Comment of the Draft Scoping Document for the DEIS to the Proposed Emergency Ventilation Plant

My name is Fred Arcaro, member of the Board of Trustees of The Murray Hill Neighbored Association. Thank you for the opportunity to comment on the scoping for your DEIS to the Proposed Emergency Ventilation Plant.

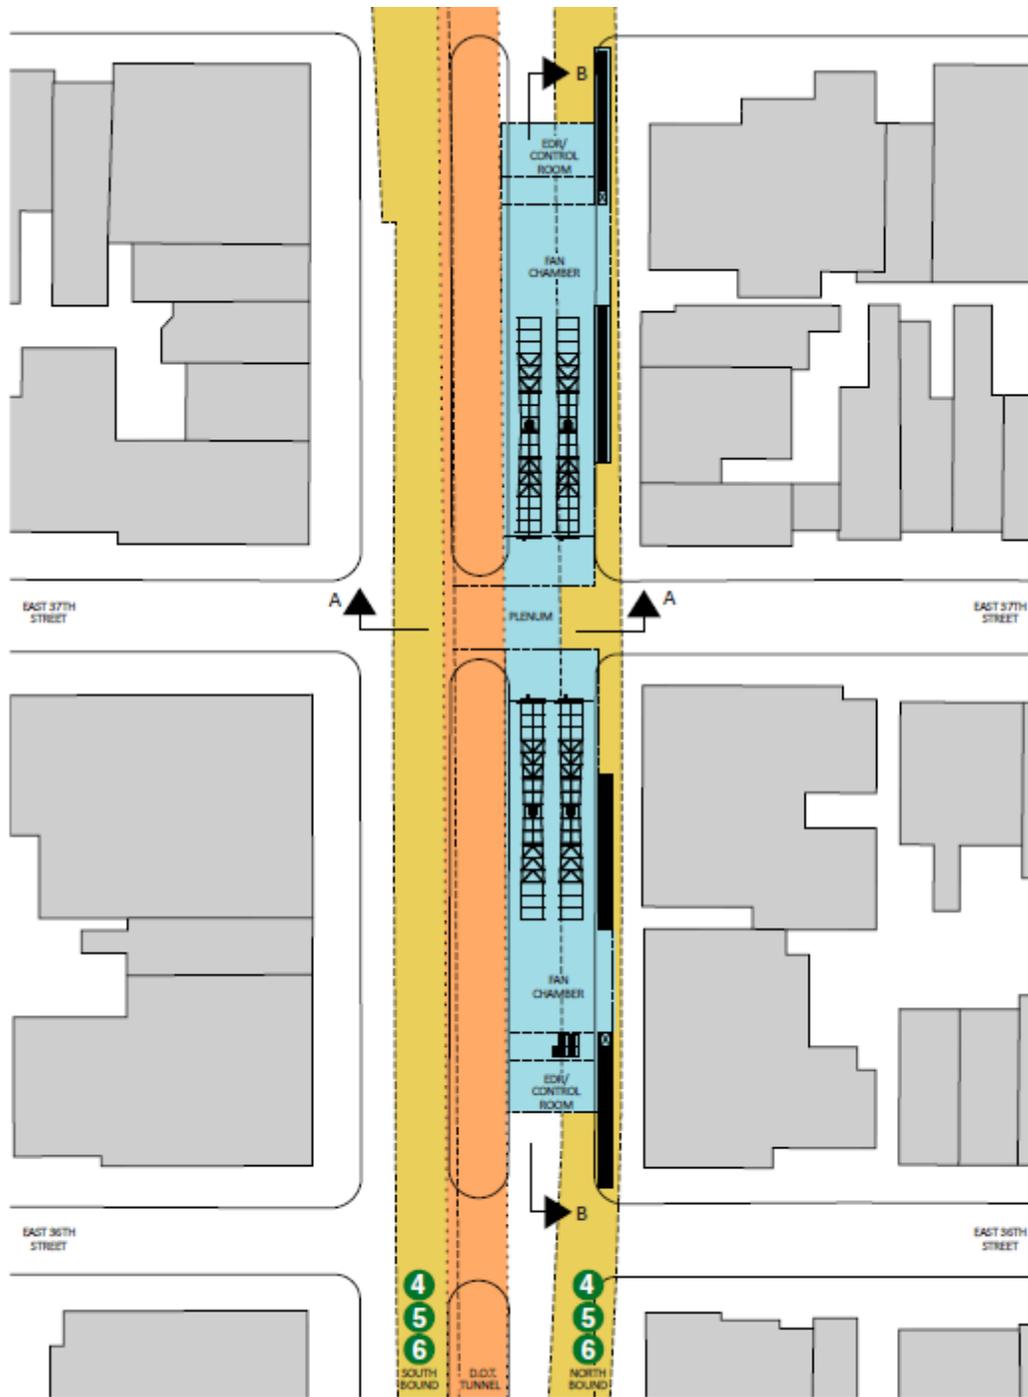
- **On page 12 of the scoping, table B-1, you indicated, for Alternative 12, the width of the fan plant to be 32 feet and the construction zone to be 37 feet.**

If this is true, the width of the construction zone would be less than indicated on page 71, Figure B-48. If one looks at Figure D-23, on page 150, the work zone would take only one lane of traffic.

Alternative 12 - Plan
 Park Avenue Between East 36th Street and East 38th Street

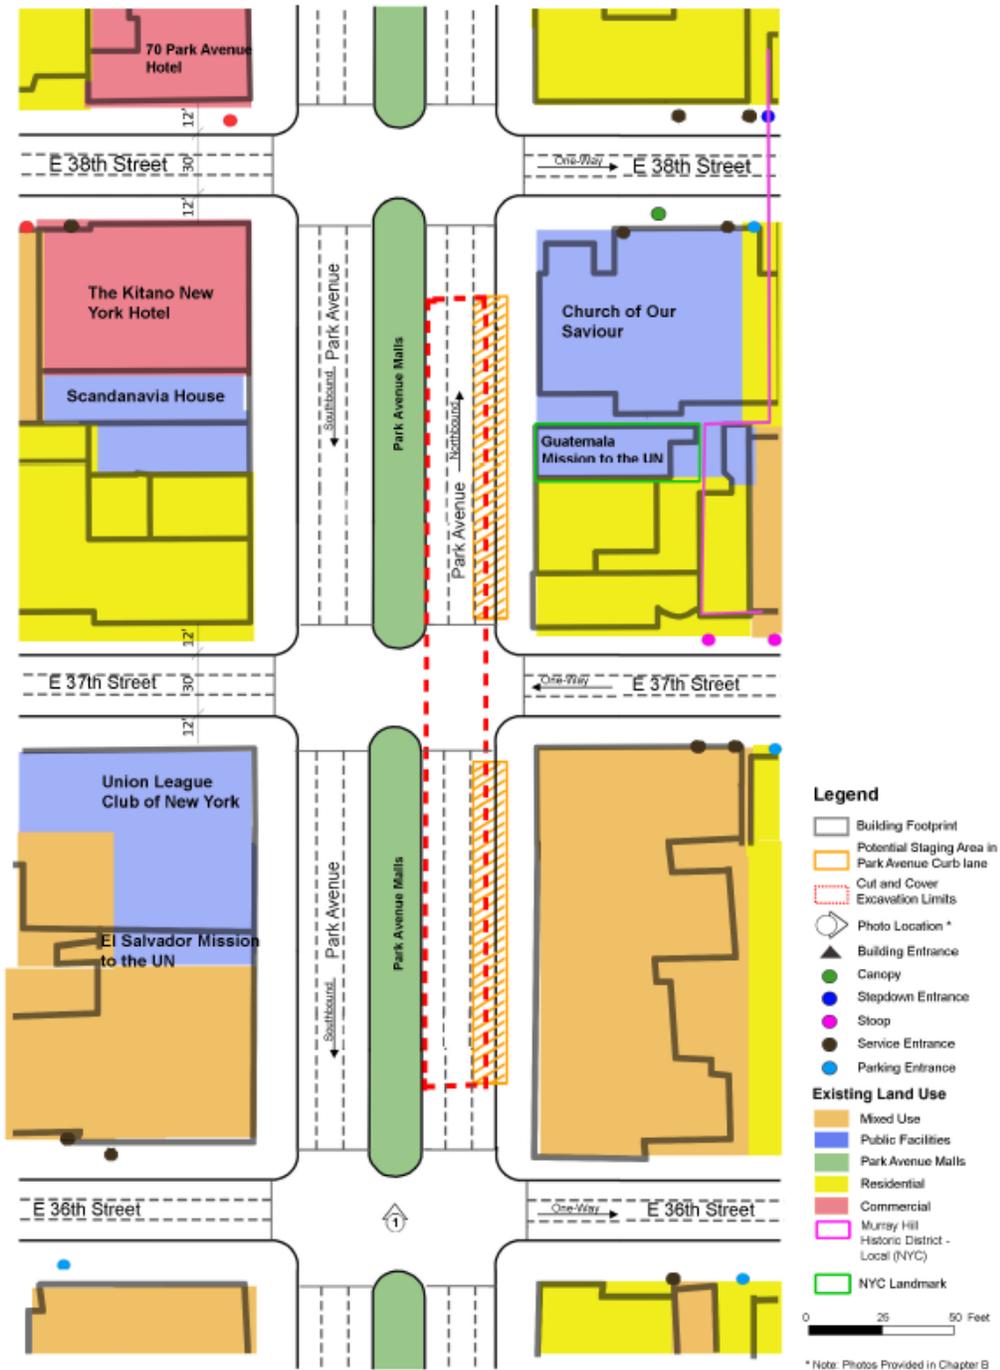
By having two lanes of traffic instead of one, it would greatly reduce the adverse impact to traffic congestion in our neighborhood.
